# UNITED STATES PATENT AND TRADEMARK OFFICE

APPLICATION NO.	FILING DATE	FIRST NAMED INVENTOR	ATTORNEY DOCKET NO.	CONFIRMATION NO.
10/034,782	12/27/2001	Lisa M. Parker	580755.003	9050

## Office Action Summary

## **DETAILED ACTION**

*Fig. 3*

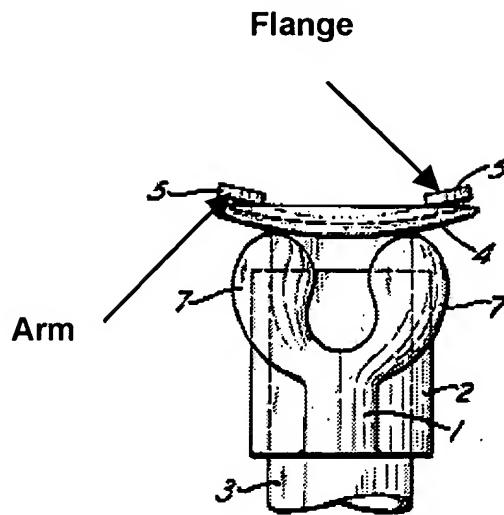
- a bite block extending from an interior surface of said disk (at 5), wherein said bite block comprises:
- an arm extending substantially perpendicular to the interior surface of said disk (See illustration of Fig. 3 below); and
- a flange extending substantially perpendicular to said arm (See illustration of Fig. 3 below).

The difference between Neidhart and claim 12 is the width of said arm and the width of said flange being less than or substantially equal to 15 mm.

At the time the invention was made, it would have been an obvious matter of design choice to a person of ordinary skill in the art to have the width of said arm and the width of said flange being less than or substantially equal to 15 mm. because regardless of what the width of the arm and flange the device is held in the users mouth on the width of the arm and flange and one of ordinary skill would know that different size width's for the arm and flange would be required for different sized individuals.

Furthermore, applicant has not disclosed that having the width of said arm and the width of said flange being less than or substantially equal to 15 mm provides an advantage, is used for a particular purpose, or solves a stated problem. Therefore, it would have been obvious an obvious matter of design choice to modify Moulton to obtain the invention as specified in claim 12.
